DRIP TROUGH

WEBSTER UNIVERSITY ISB	
PROJECT NAME	
8274 BIG BEND BLVD	
ADDRESS	
NUMBER	
WEBSTER UNIVERSITY	
OWNER	
CANNON DESIGN	
ARCHITECT / ENGINEER	
DEVIN D GATES	
SUBMITTED BY	
123553-001 REV 2	
CONTRACTOR / CM SUBMITTAL NO.	CANNON DESIGN SUBMITTAL NO.
	123553
DRAWING / DETAIL REFERENCE	SPECIFICATION SECTION / PARAGRAPH
MANUFACTURER / SUPPLIER	ITEM / PRODUCT ID
REQUIRED DATE	PRIORITY
	CRITICAL

12 3553-001 REV003
CANNON DESIGN SUBMITTAL NUMBER
2/1/17
RECEIVED DATE

DATE: 1/25/2017
JOB: 04437A, B, C, D
RE: Webster University
Webster Groves, MO

40900 - <6679A>

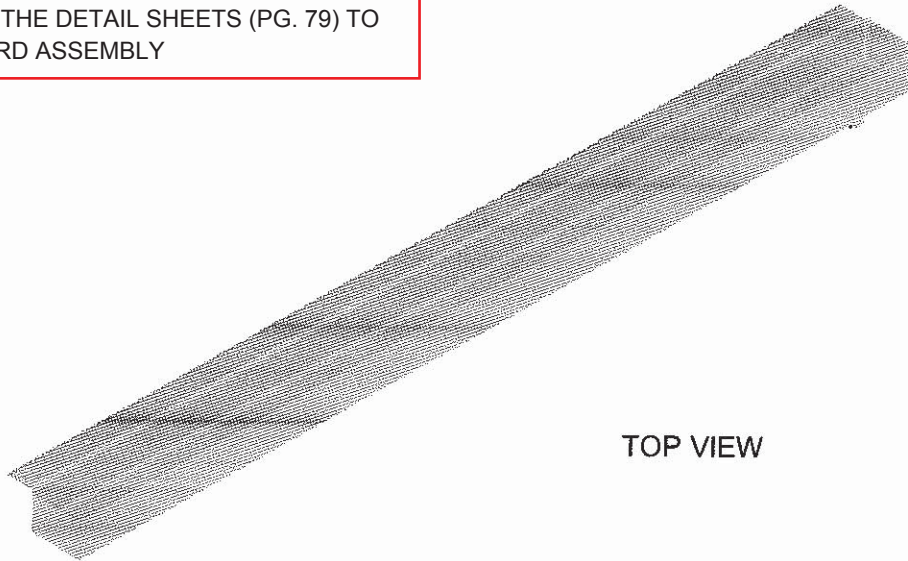
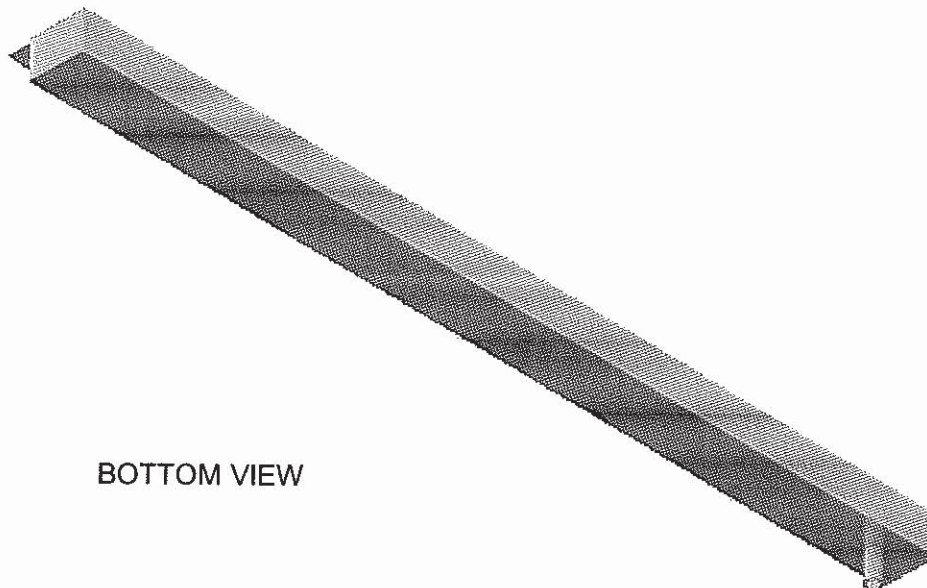
SATIN FINISH-
NOT AN OPTION
